Pulaski County Schools
Energy Savings and Performance Contract
Addendum #2
March 25th, 2022

CMTA Contact:	Megan Brangers
Email:	MBrangers@cmta.com
Cell Phone:	502-919-1521

The following information supersedes or is in addition to information released in the Contract Documents dated March 11th, 2022 and addendum 1 dated March 18th, 2022.

GEOTHERMAL PIPING SCHEMATIC - CUSTODIAL RECEIVING 041
SCALE: NTS

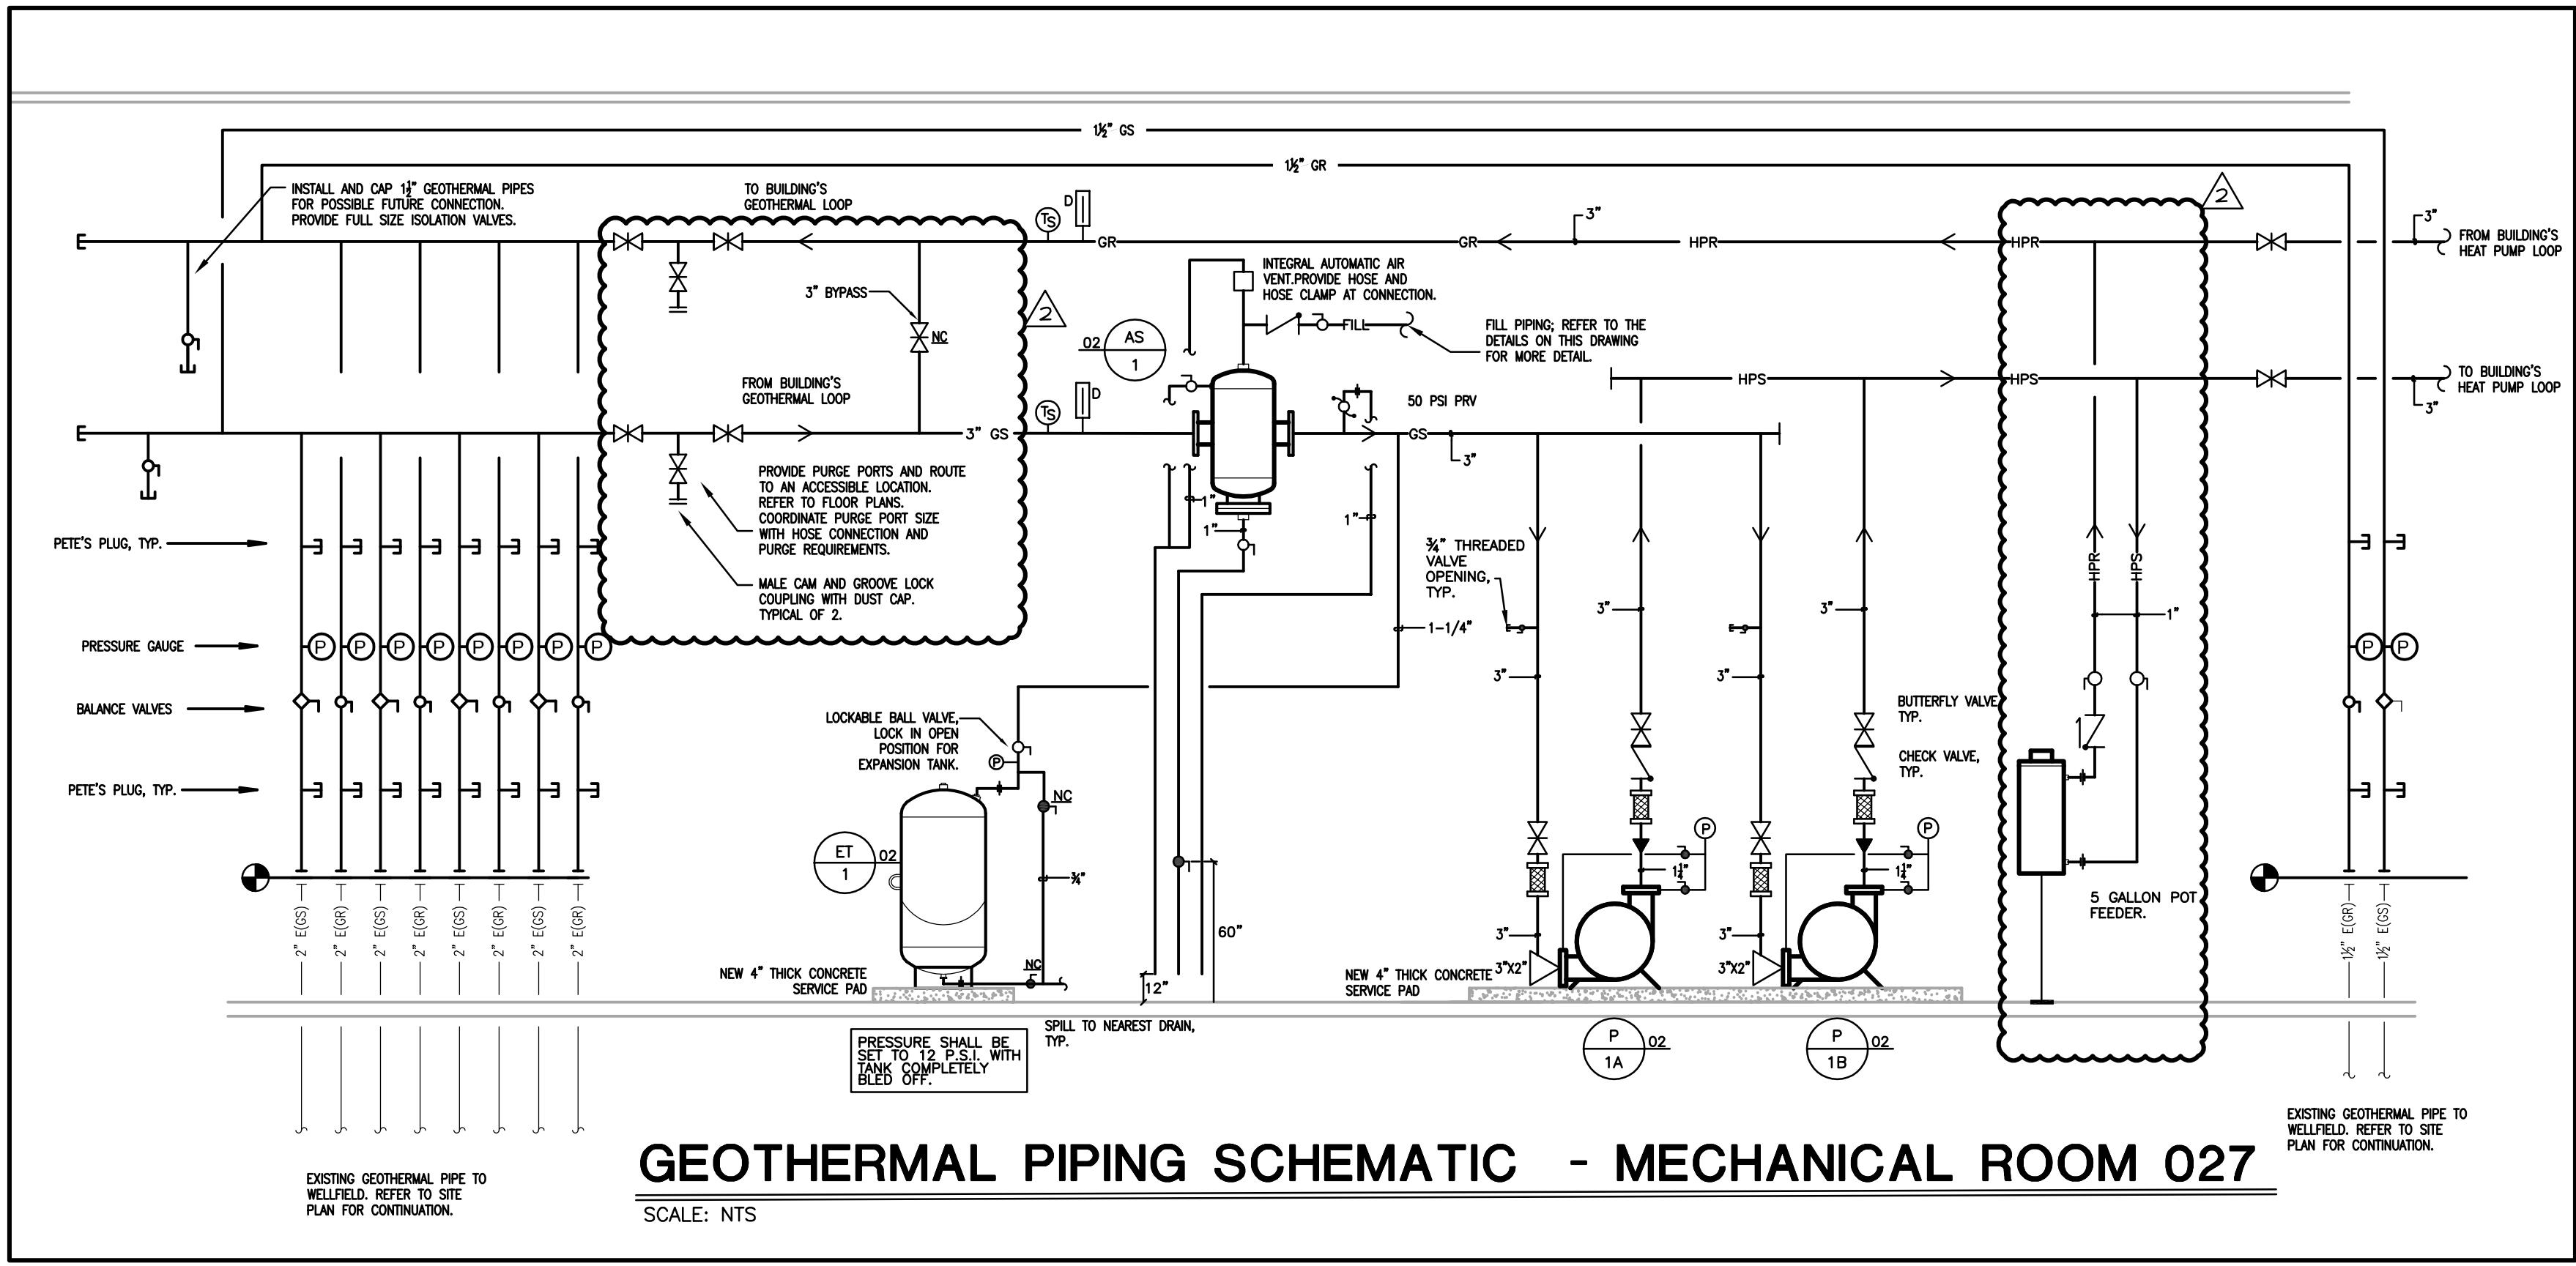
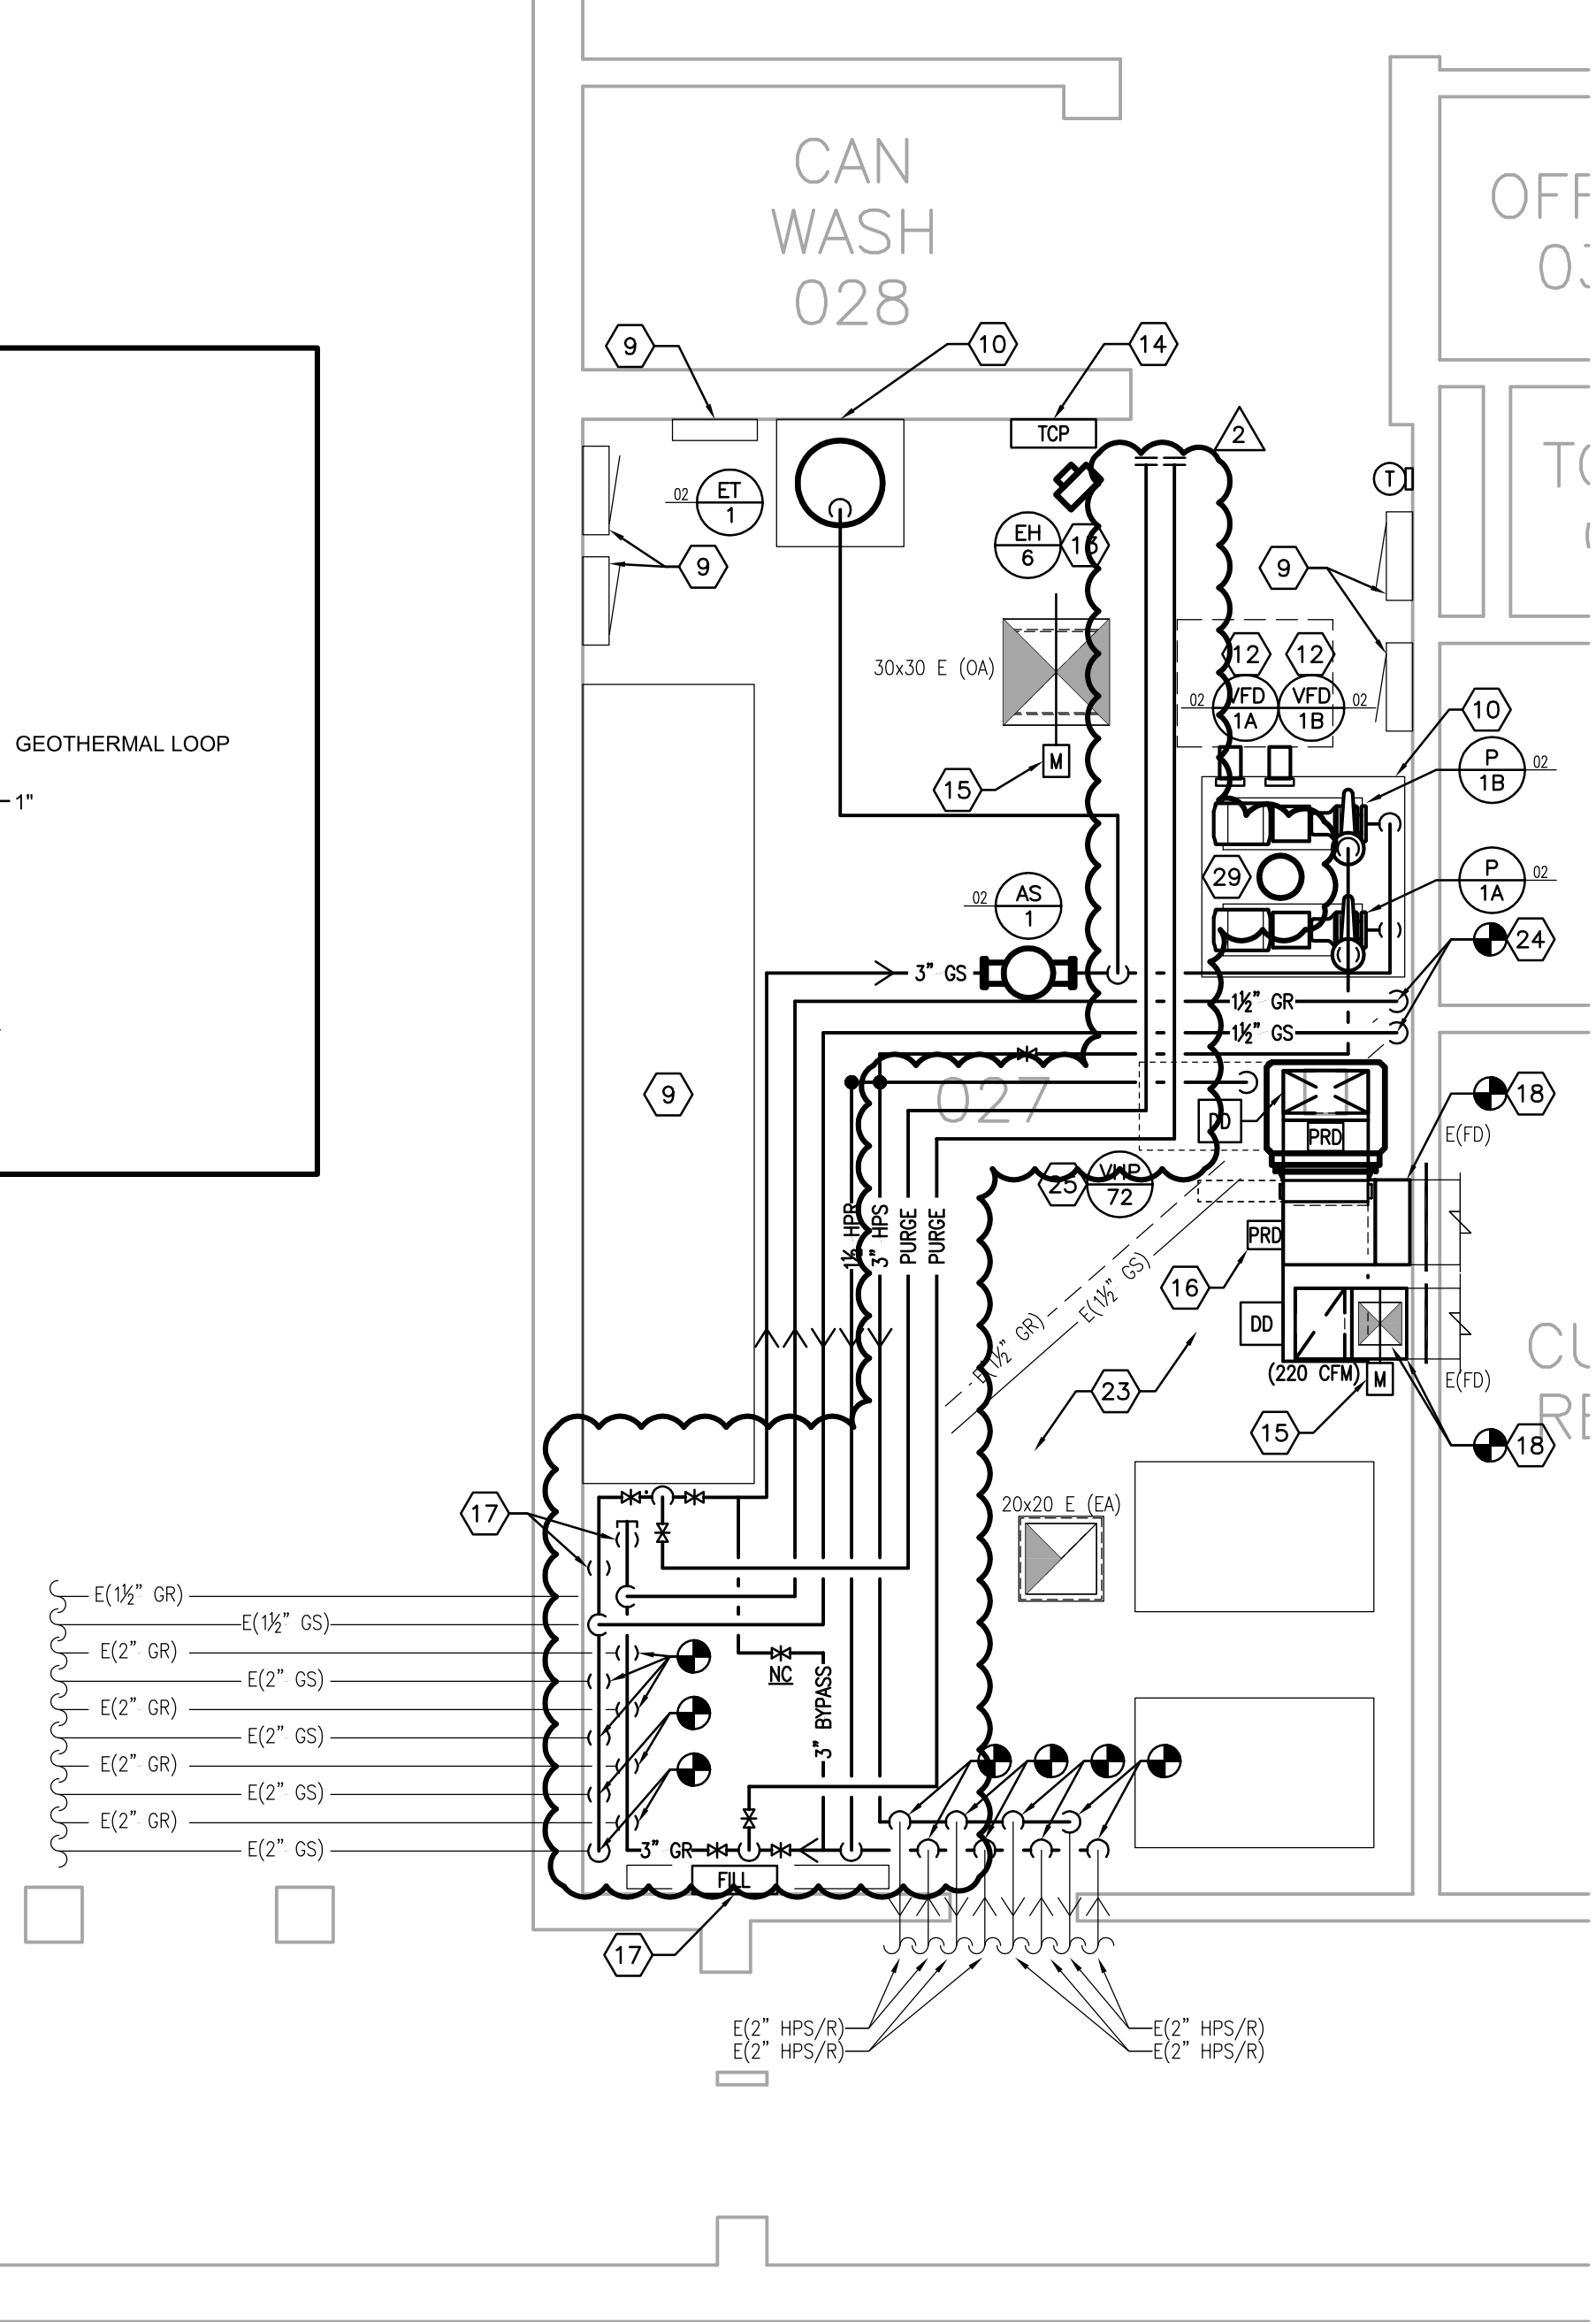
14. Drawing M2-5.0

- a. Refer to Mechanical Room 027 for revised geothermal and heat pump piping. Add geothermal wellfield bypass and purge ports. Add 5-gallon pot feeder.
- b. Refer to Custodial Receiving 041 for revised geothermal and heat pump piping. Add geothermal wellfield bypass and purge ports.
- c. Refer to 'Geothermal Piping Schematic - Custodial Receiving 041' for updates. Add geothermal wellfield bypass and purge ports.
- d. Refer to 'Geothermal Piping Schematic - Mechanical Room 027' for updates. Add geothermal wellfield bypass and purge ports. Add 5-gallon pot feeder.
